From: Detterman, Mark, Env. Health
Sent: Tuesday, June 27, 2017 2:45 PM
To: 'Bob Clark-Riddell'
Cc: Jake Wilson
Subject: RE: 51st & Broadway Excavation

From: Jake Wilson [<mailto:jwilson@pangeaenv.com>]
Sent: Friday, June 23, 2017 10:28 AM
To: Detterman, Mark, Env. Health <Mark.Detterman@acgov.org>
Subject: 51st & Broadway Excavation

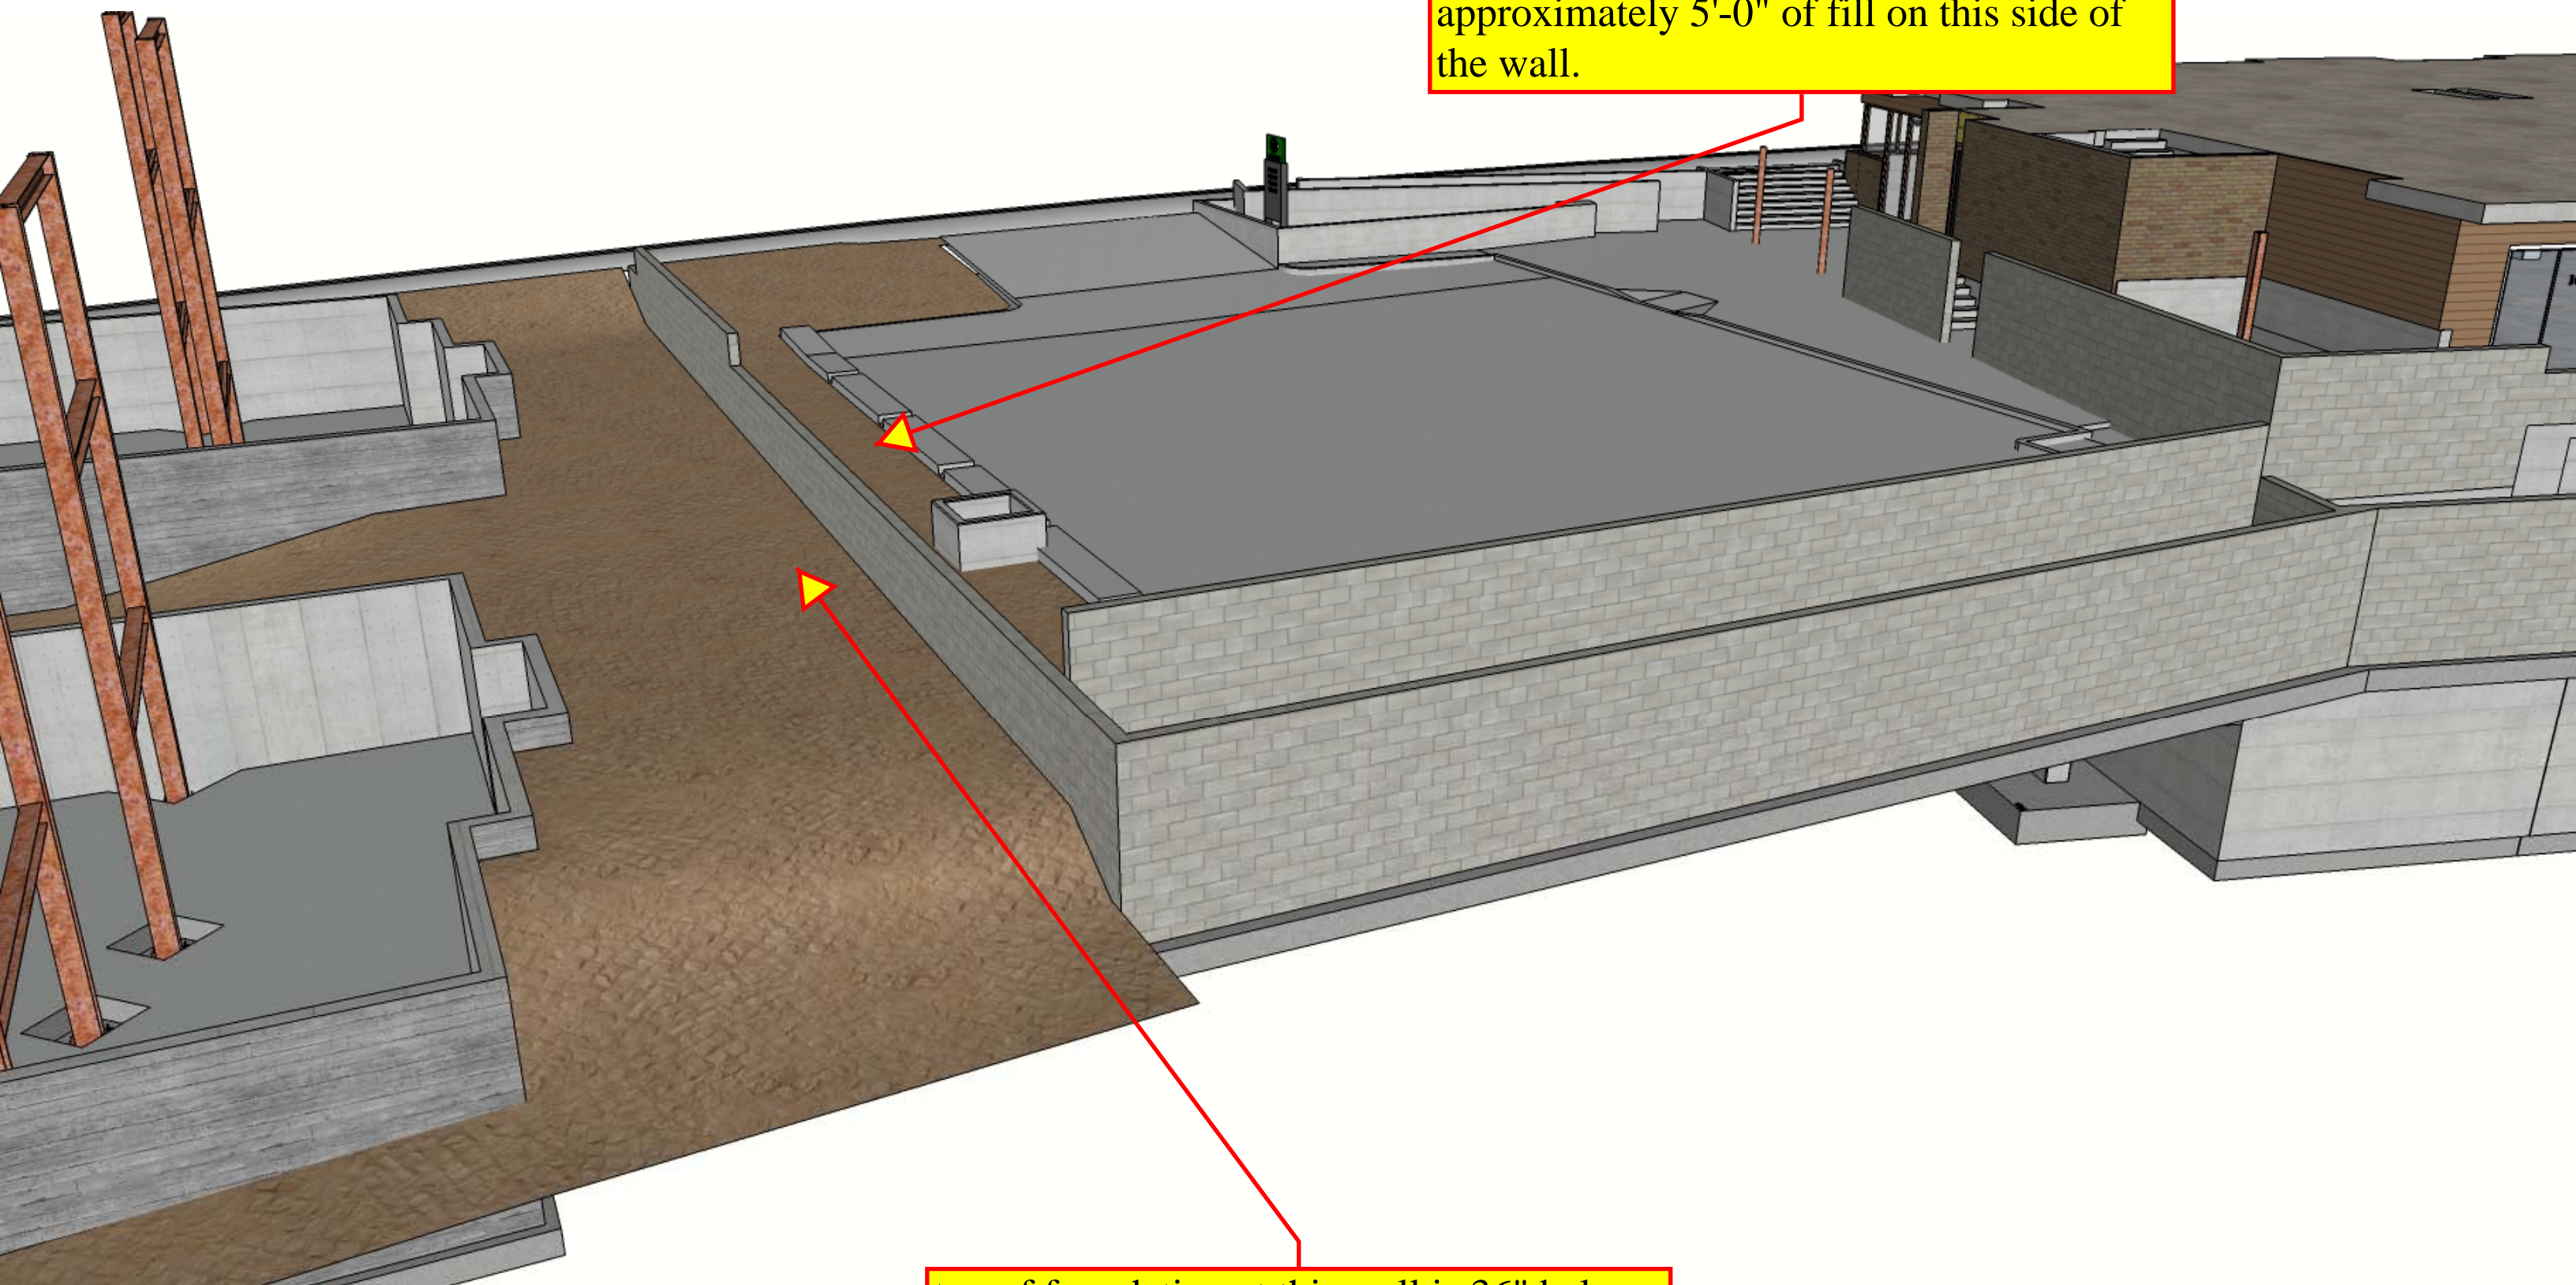
Hi Jake,
Based on my quick the review it appears that samples with elevated lead concentrations are laterally constrained by other lower samples, as well as to the north and to the south by the property lines of the parcels, and to the east by the new building, and thus additional samples do not appear to be needed. This analysis is based on the understanding that areas in blue and "yellow" will be removed and appropriately managed for offsite disposal.

However, please verify that the "eastern" edge of Figure 4 is the building, rather than landscaping between the subject parcels and the new building. If landscaping, then additional lateral sidewall samples would be appropriate to define the "eastern" lateral extent of impacted soil between the parcels and the building.
Thanks; I'll look forward to your response.

Per our phone conversation yesterday, you are correct in that the samples taken from the areas not highlighted in blue, light yellow, or gold were taken from what will be the bottom of the excavation once complete.

Can you reply with confirmation that we do not need to collect sidewall or bottom sample from the highlighted areas?

Thanks for info. At this point it appears appropriate to use the information you attached in a report to support your thinking that no further lateral sampling is required, provided you are in agreement. Unless I'm missing something, from what I can determine, and you should verify, the block wall foundation will be 36-inches below grade, but that it will be founded on 5 feet of imported fill. Should there be a need for confirmation samples to the east, I would guess that they might be "needed" at the base of the five feet of fill, unless that's below the depth of impacted soil removal already done.
